Compliance with EU Battery Regulations

June 2024

MELSEC series, MELIPC series, and GOT2000 series

FA-A-0436-A

■ Q6BAT

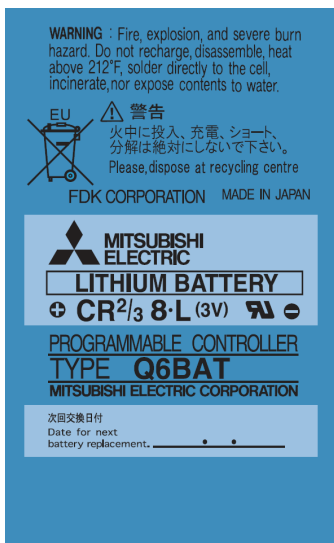
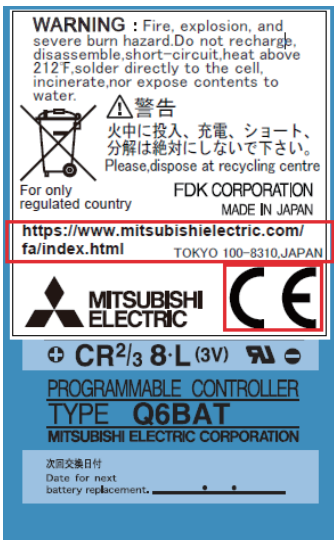
A sticker will be attached, or the label will be changed.

Before change	After change
 <p>The 'Before change' label is a blue rectangular sticker. At the top, it contains a warning in English: 'WARNING : Fire, explosion, and severe burn hazard. Do not recharge, disassemble, heat above 212°F, solder directly to the cell, incinerate, nor expose contents to water.' Below this is a warning symbol (triangle with exclamation mark) and Japanese text: '警告 火中に投入、充電、ショート、分解は絶対にしないで下さい。 Please, dispose at recycling centre.' To the left of the Japanese text is a crossed-out recycling symbol. Below the warning is 'FDK CORPORATION MADE IN JAPAN'. The main body of the label features the Mitsubishi Electric logo, 'LITHIUM BATTERY', 'CR²/₃ 8·L (3V)', and 'PROGRAMMABLE CONTROLLER TYPE Q6BAT MITSUBISHI ELECTRIC CORPORATION'. At the bottom, there is a field for '次回交換日付 Date for next battery replacement.' with a line and two dots for a date.</p>	<p>• Stickers attached</p>  <p>The 'After change' label shows the same blue sticker as before, but with a white rectangular sticker attached to its top half. The white sticker contains the same warning text and symbols as the top of the blue sticker. Below the warning, it says 'For only regulated country' and 'FDK CORPORATION MADE IN JAPAN'. A red box highlights the URL 'https://www.mitsubishielectric.com/fa/index.html' and 'TOKYO 100-8310, JAPAN'. Below this is the Mitsubishi Electric logo and a CE mark, both also highlighted with red boxes. The rest of the label (battery type, controller type, and date field) remains unchanged.</p> <p>• Label changed</p>  <p>The 'After change' label shows the same blue sticker as before, but with the top half replaced by a new white section. This new section contains the warning text and symbols. Below the warning, it says 'For only regulated country' and 'FDK CORPORATION MADE IN JAPAN'. A red box highlights the URL 'https://www.mitsubishielectric.com/fa/index.html' and 'TOKYO 100-8310, JAPAN'. Below this is the Mitsubishi Electric logo and a CE mark, both also highlighted with red boxes. The rest of the label (battery type, controller type, and date field) remains unchanged.</p>

■ Q2MEM-BAT

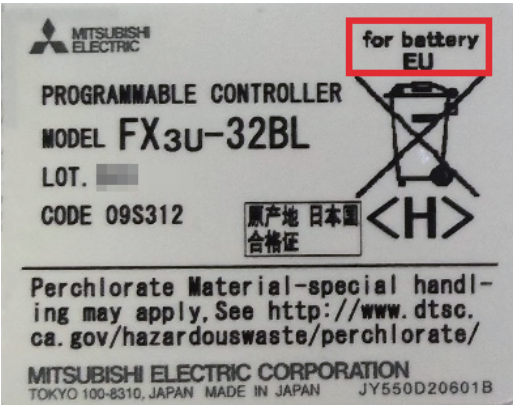
The CE mark, our head office address, and our website URL will be added on the rear of the packaging.
